MEMORANDUM

SUBJECT: Permit renewal staff analysis: Last Chance/Ponds Lodge wastewater treatment and reuse facility; permit number LA-000058-03

Monitoring Results

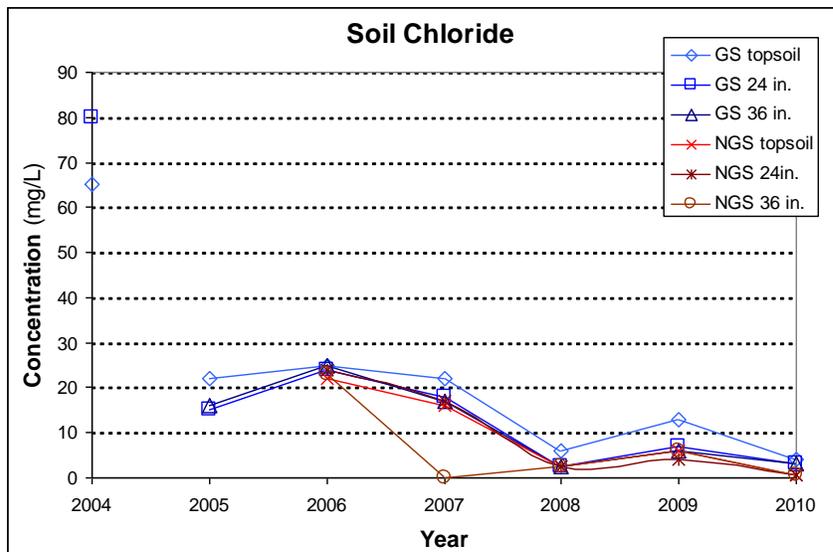
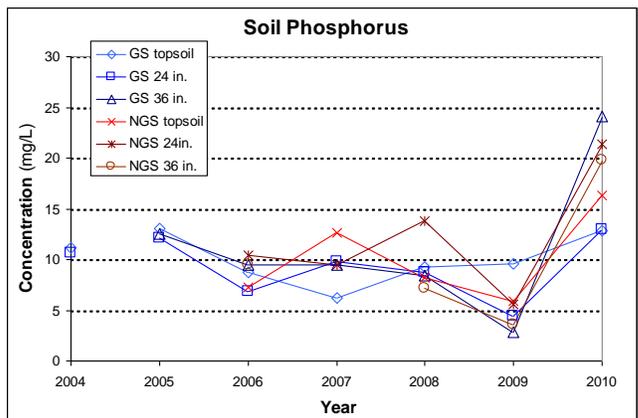
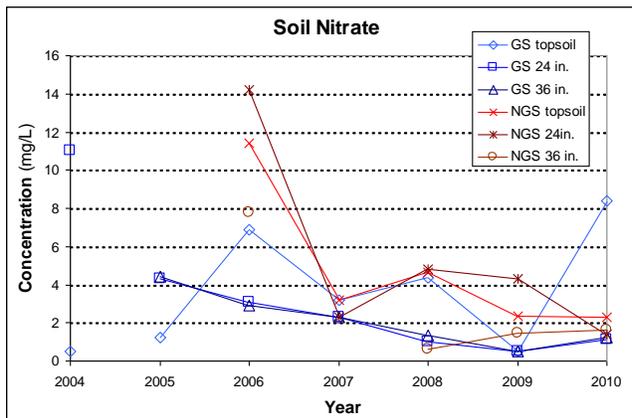
The last five years' soil monitoring data shows no levels of concern for either the growing season or non growing season acreage. Nitrate, phosphorus and chloride are charted below.

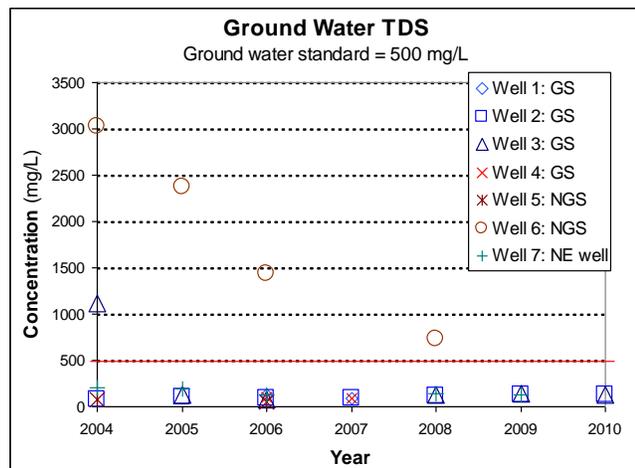
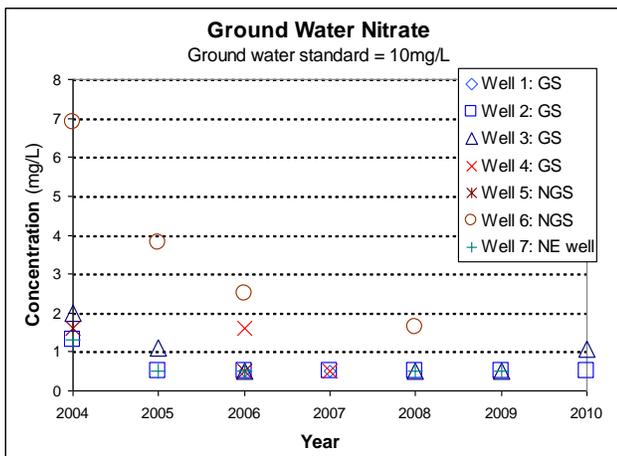
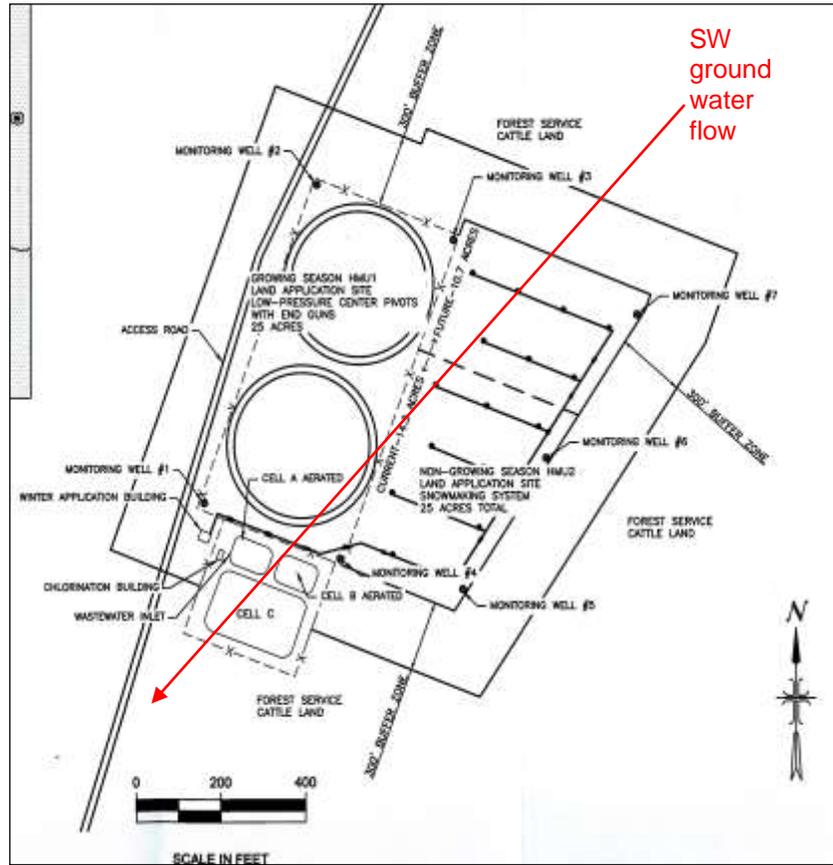
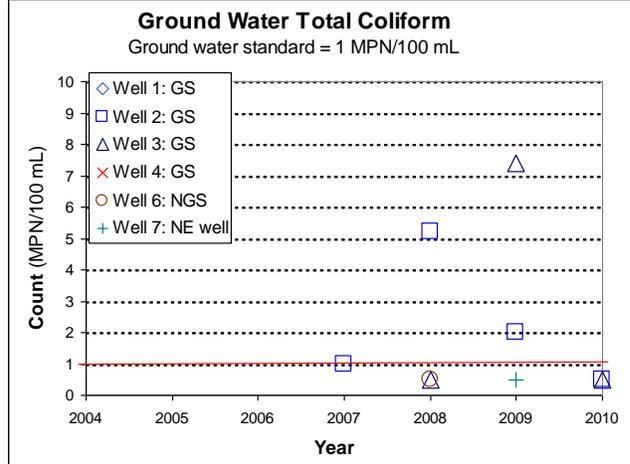
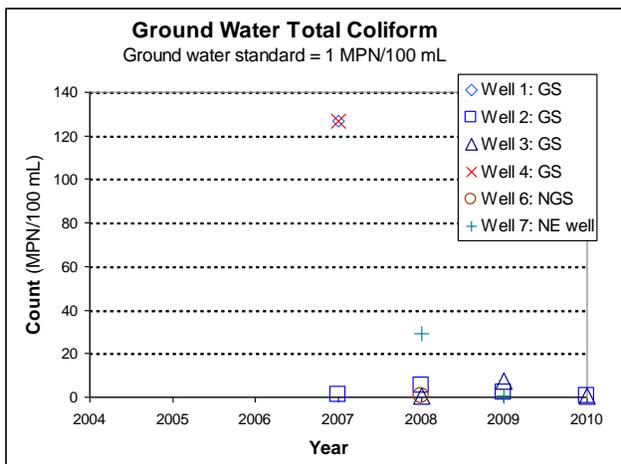
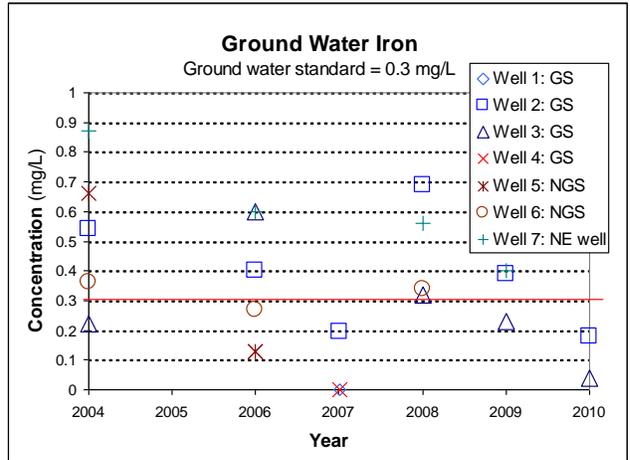
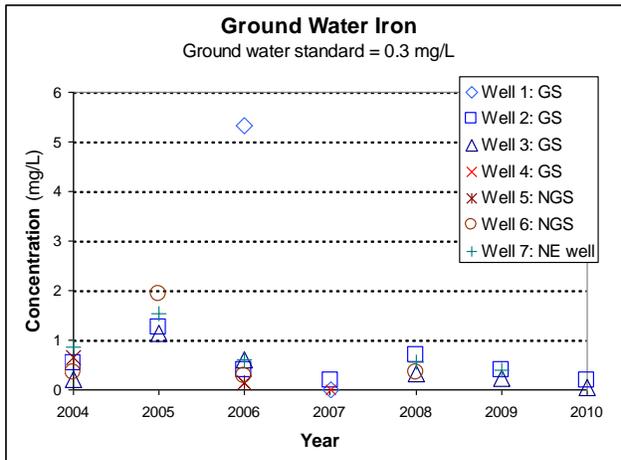
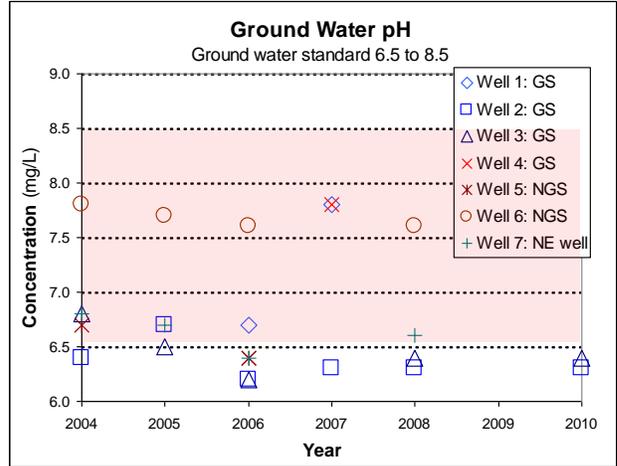
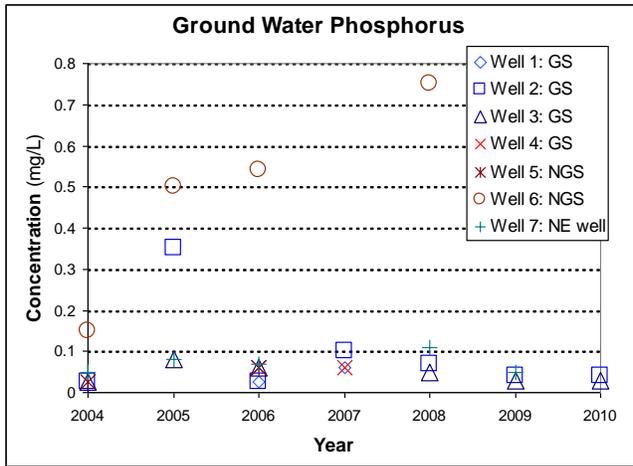
1. Dry wells:
 - a. Wells 1 and 4 were dry for 5 of the last 7 years (7 of the last 9 sampling events).
 - b. Well 5 was dry for 4½ of the last 7 years (5 of the last 9 sampling events).

2. Well 6 appears to have construction issues based on the monitoring results, specifically nitrate, TDS, and phosphorus. The results may be due to improper well sealing; however, the well appears to be improving with time.

3. Wells 2 & 3 appear to have pH issues: both have historically dipped below the 6.5 secondary ground water quality standard.
4. There have been coliform exceedances in ground water due to chlorine disinfection equipment malfunctions. Further, the use of drinking water sampling bottles resulted in residual chlorine removal and therefore coliform growth after sample collection and prior to lab analysis. Both of these issues have been resolved.

5. Wells 2 and 3 have low pH and high iron, which may reflect chemically reducing environments due to soil saturation.
